FOR: HVAC Replacement
FFA Leadership Center Recreation Hall
Kentucky Department of Education
Hardinsburg, Kentucky

ADDENDUM NO. One (1)

ADDENDUM NO. 1

TO: All Plan Holders
FROM: Studio Kremer Architects
PROJECT: Future Farmers of America Leadership Camp
RECREATION BUILDING
ska# 2023-33.7

1 FIRST FLOOR PLAN - ELECTRICAL DEMOLITION
SCALE: 1/8" = 1'-0"

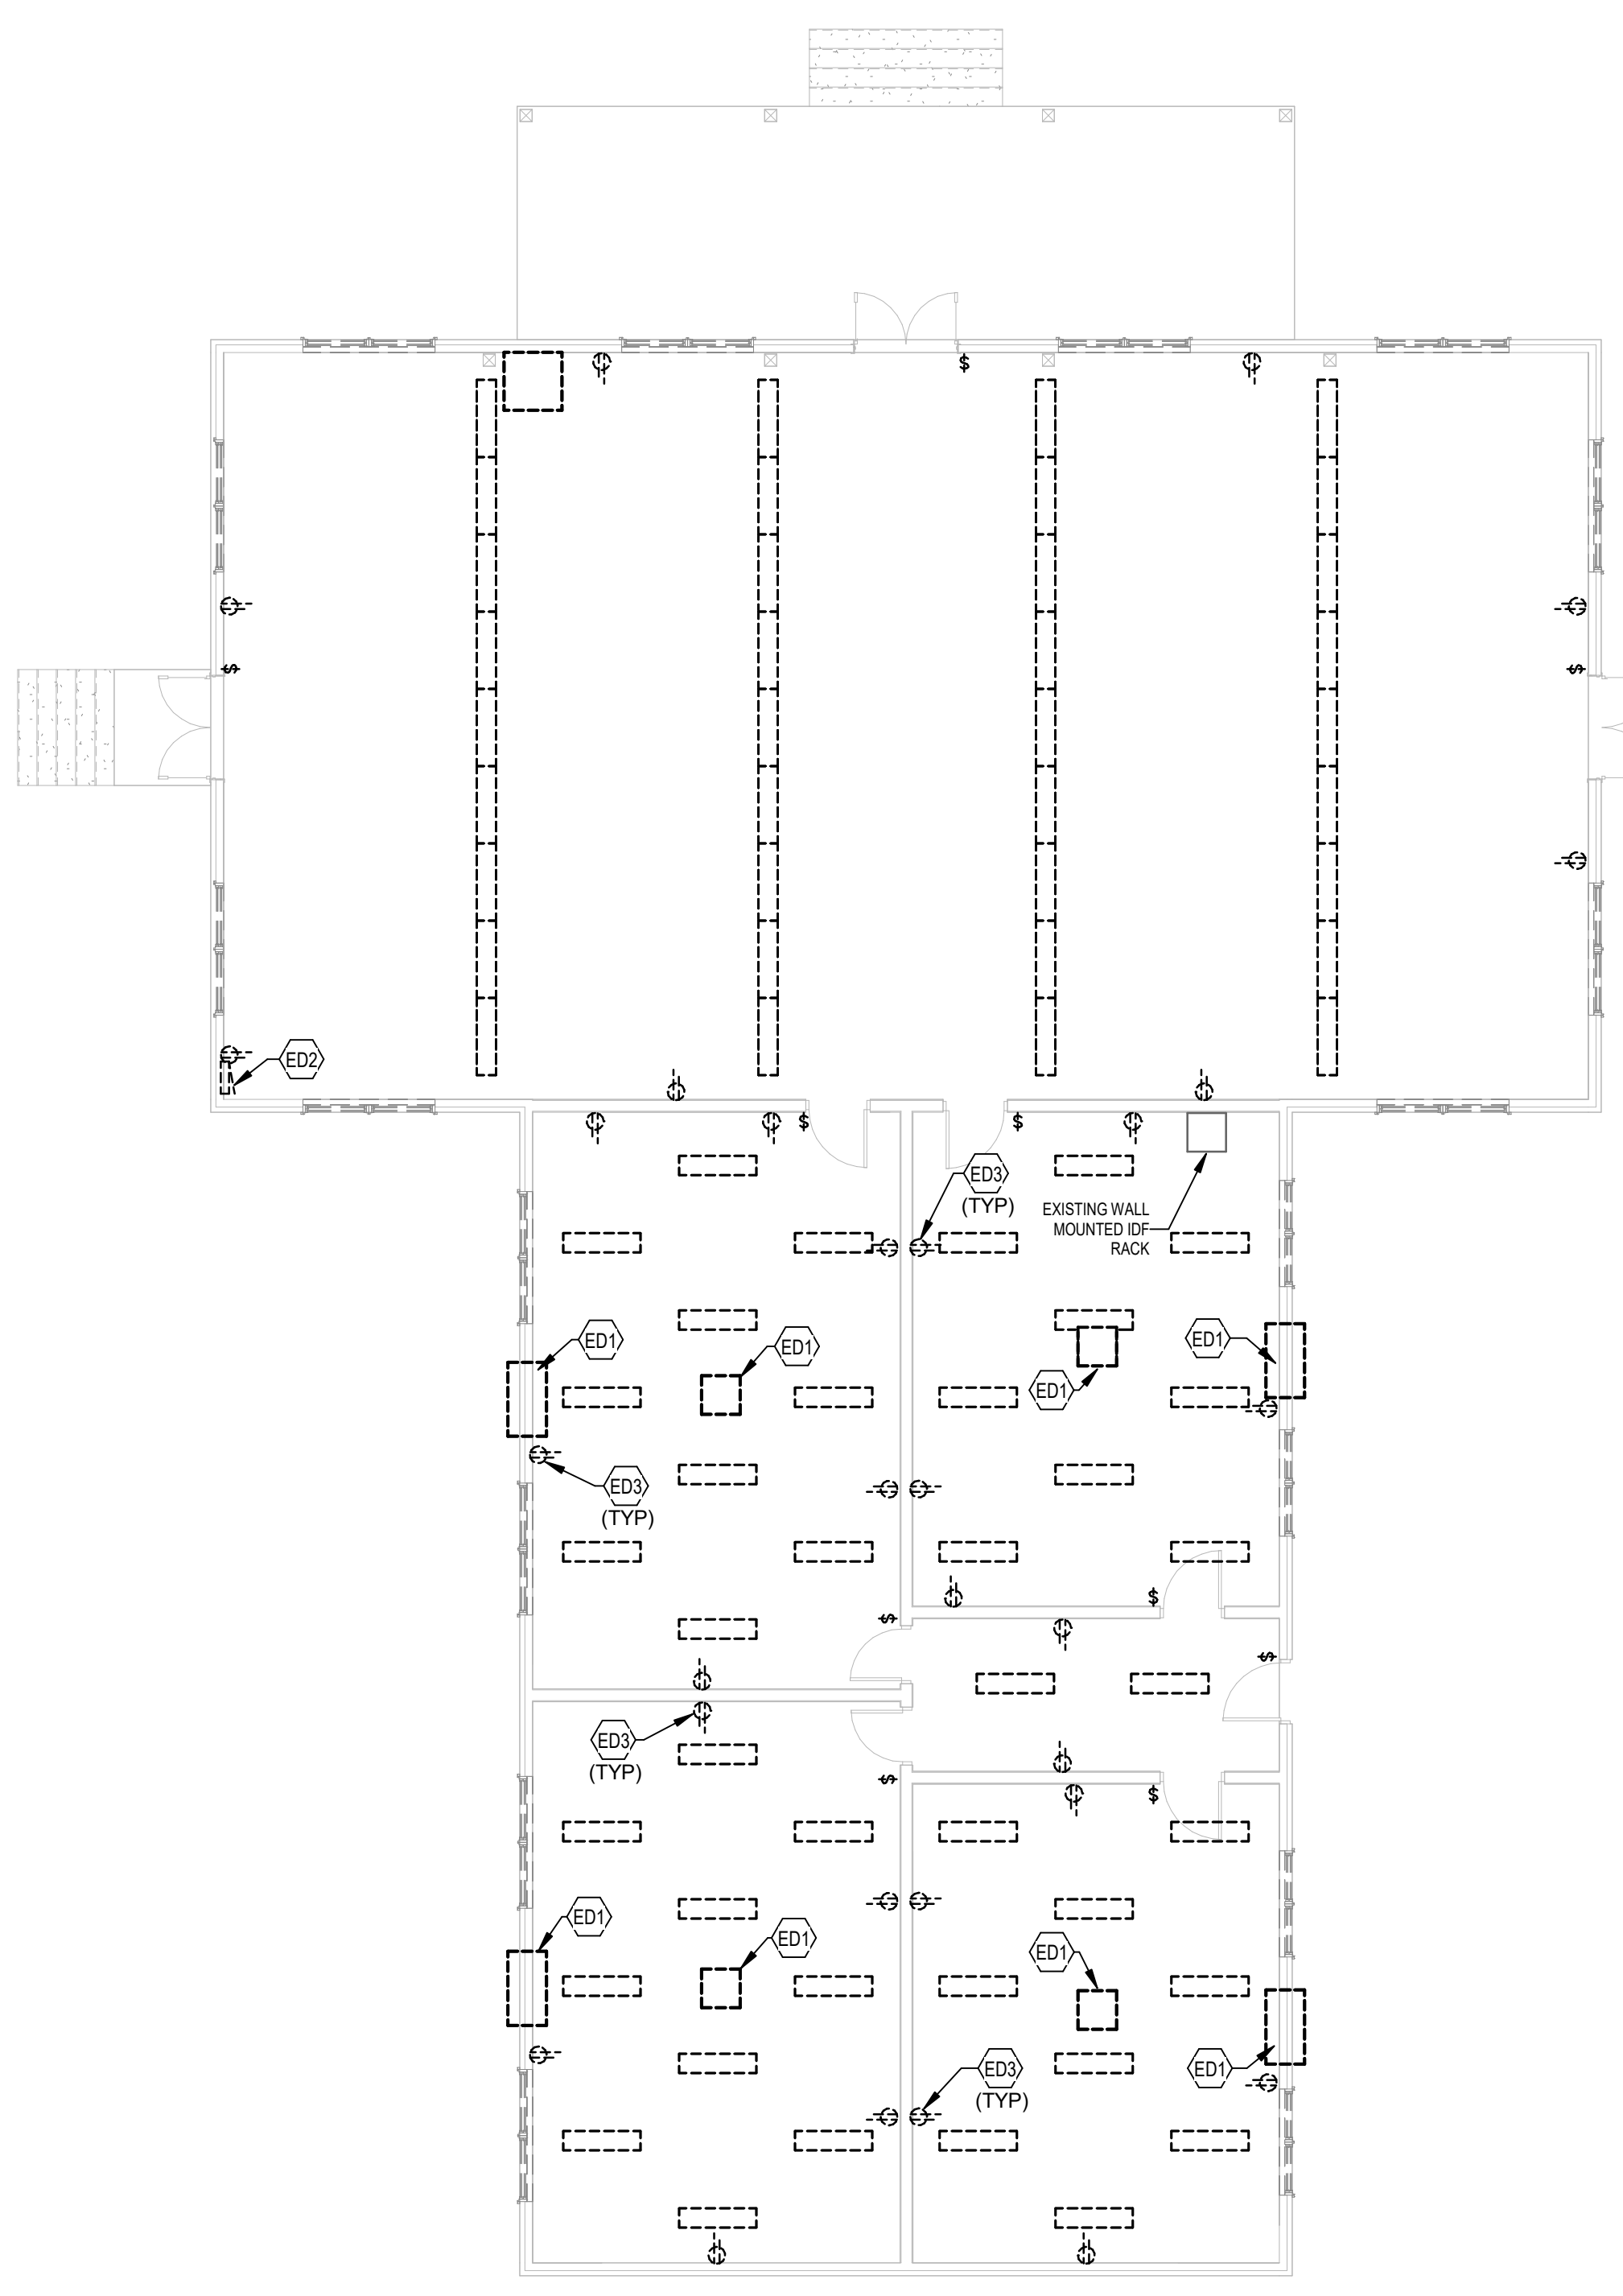
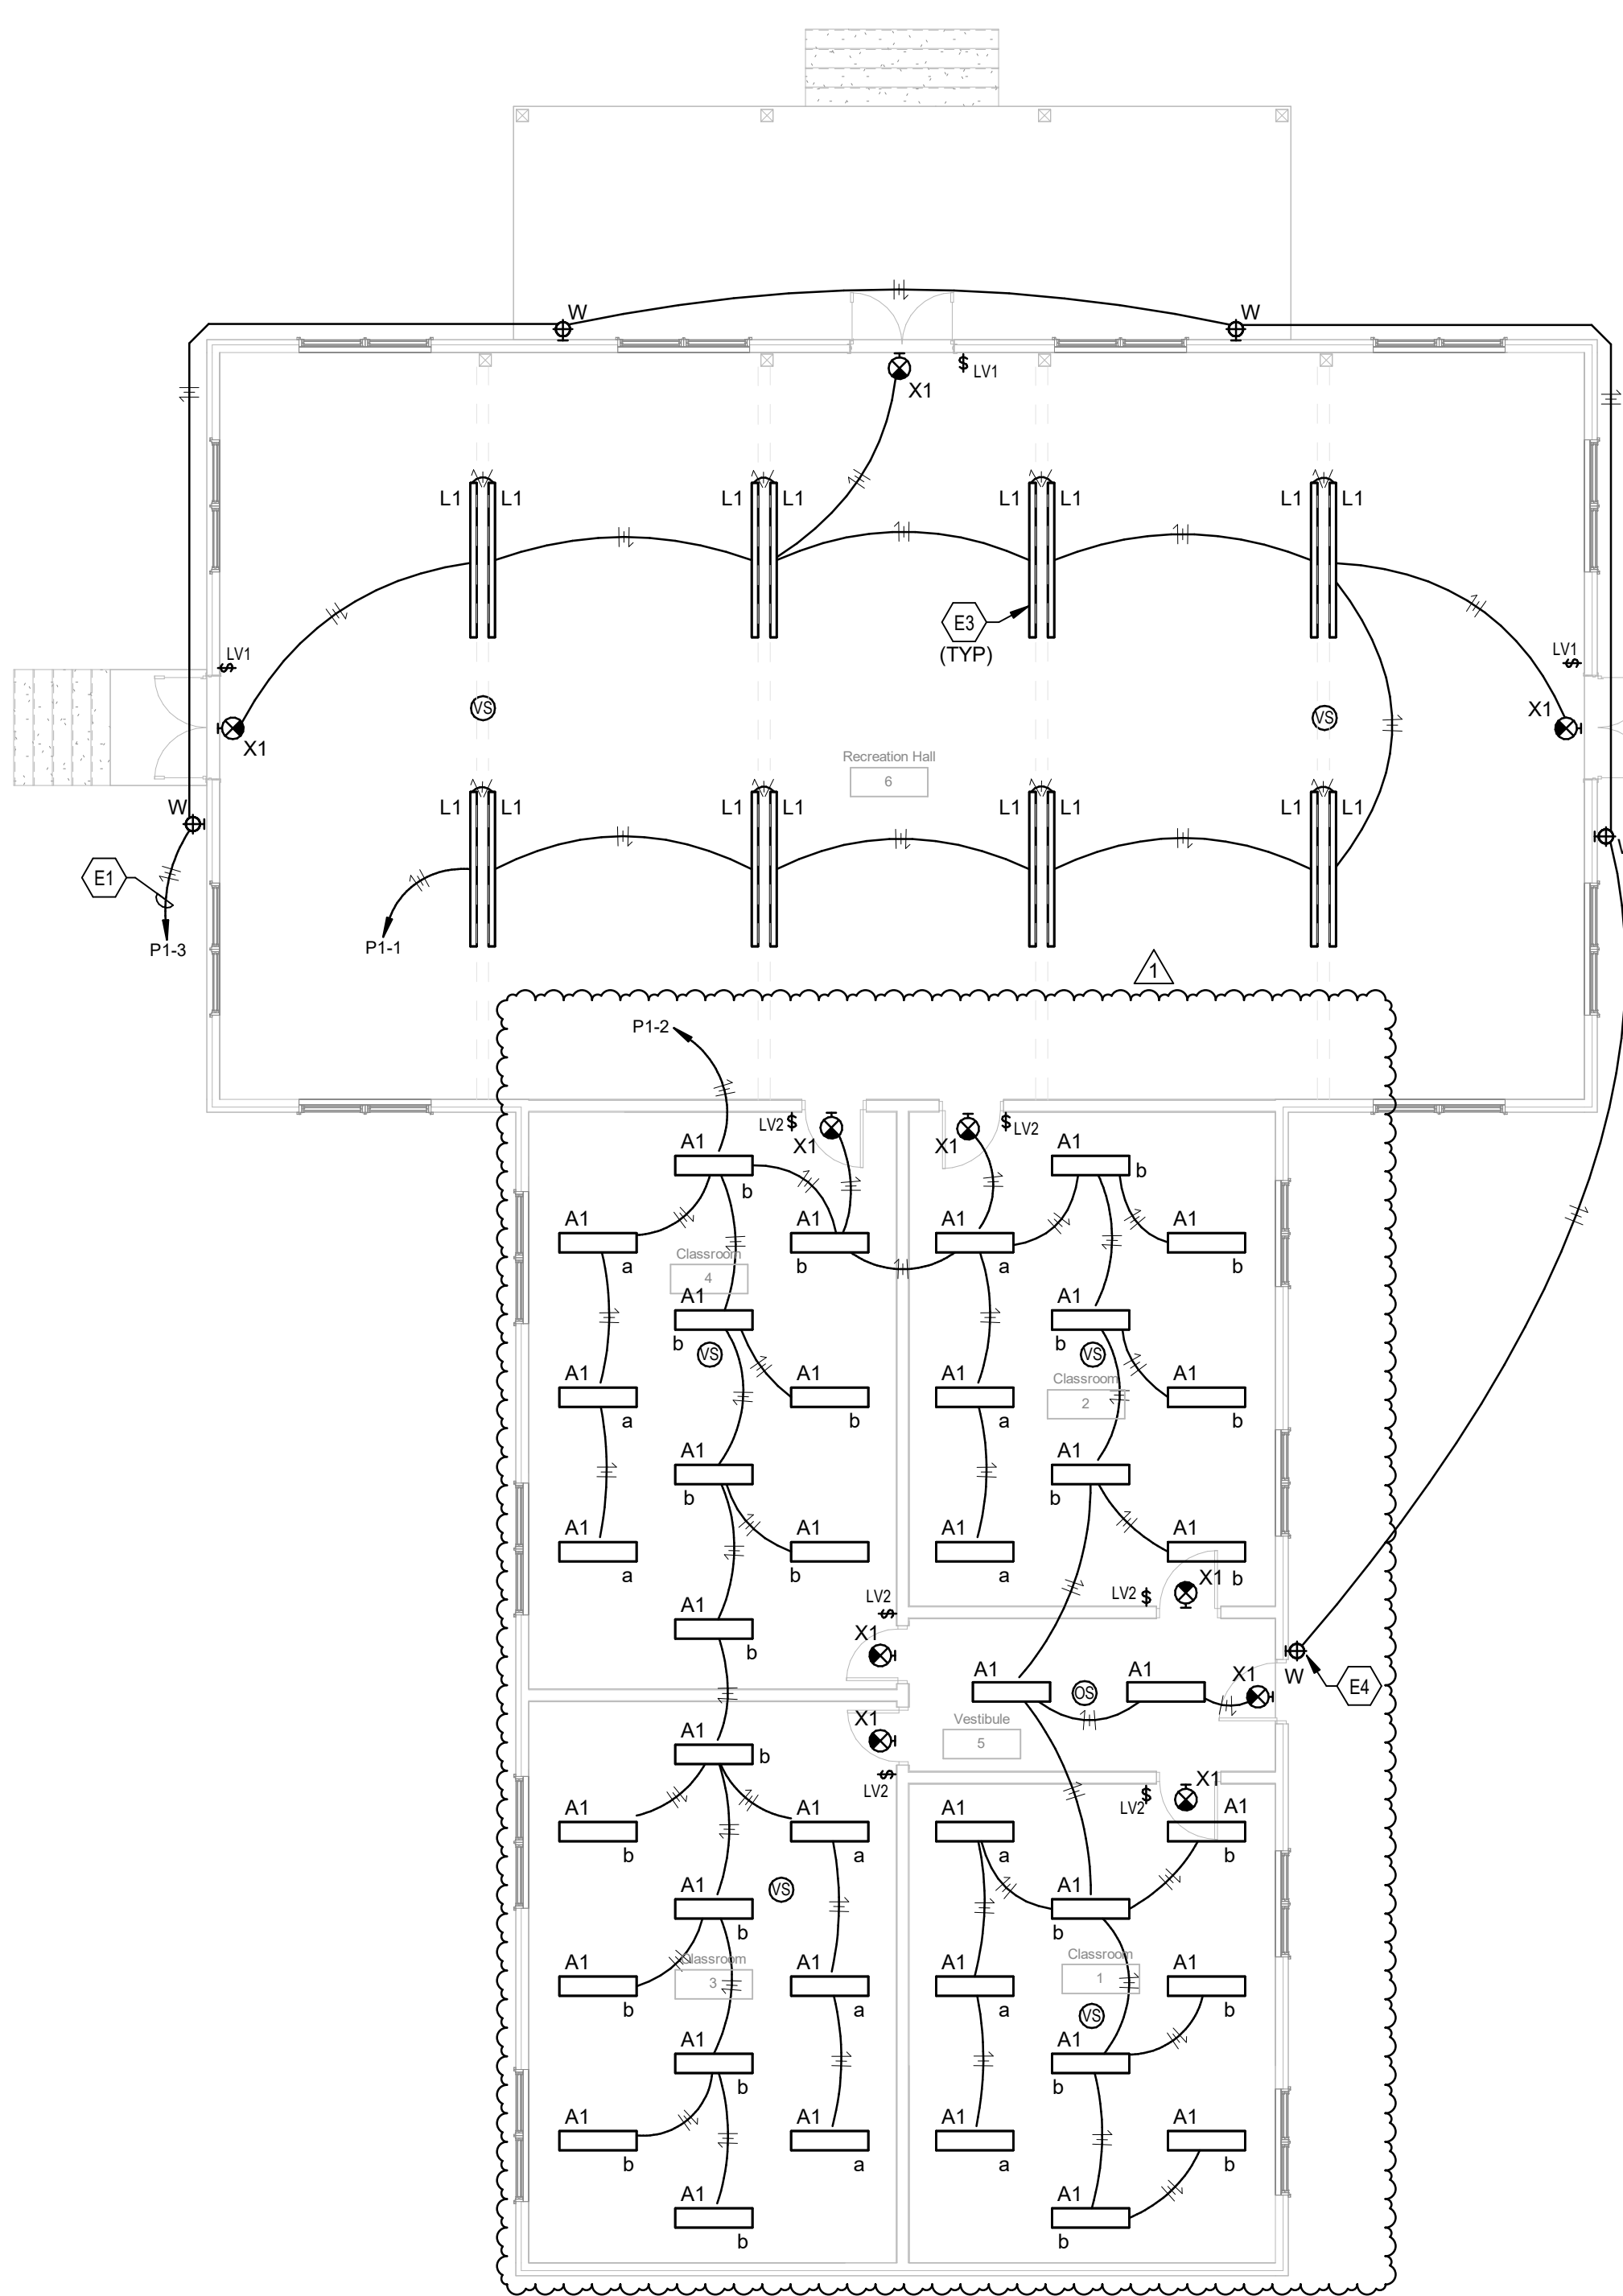
Sheet #	Sheet Title	Noted Update
E200	First Floor Plans - Electrical	Updated lighting design Updated power distribution to condensing units
E300	Electrical Details	Updated electrical keynotes
E301	Electrical Details	Updated power keynotes

Sheet E-200

First Floor Plan – Electrical Demo

First Floor Plan – Lighting & Power/Systems

CMTA Response: All existing romex shall be demoed complete.

CMTA Response: Lighting, power, and fire alarm cabling/conductors shall be in conduit.

CMTA Response: Yes, the new panelboard shall be located in similar location.

CMTA Response: MC cable is acceptable above hard wood ceiling only. New mechanical branch circuits shall remain in EMT conduit above hard wood ceiling.

CMTA Response: MC cable rated for fire alarm use is acceptable above ceiling.

CMTA Response: Fire alarm devices are acceptable to be surface mounted. New electrical devices shall utilize existing pathway where possible, any location where this is not possible surface mounted conduit is acceptable with approval of the owner or engineer.
